TR-115

VDSL2 Functionality Test Plan

Issue: 2 Amendment 1
Issue Date: May 2013

Figure 1 REIN Noise for the inhibition test of CV, ES, SES and LOSS counter

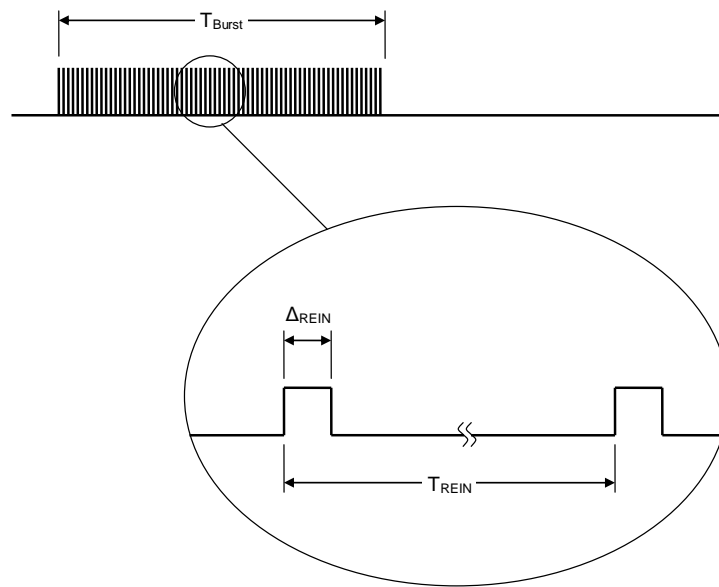
Add section 7.10 Inhibition of Performance Monitoring Counters as follows:

The test SHALL be done with bursts of the repetitive impulse noise (REIN) in addition to the background noise. The REIN noise duration is T_{Burst} . The REIN pulse consists of a “Burst of pseudo random AWGN” at a level of -90dBm/Hz differential mode from 25 kHz up to 30 MHz, where the out-of-band noise shall not be higher than -140dBm/Hz . The pulse duration Δ_{REIN} depends on the specific test profile. The pulse SHALL be repeated every 10 ms (T_{REIN}).
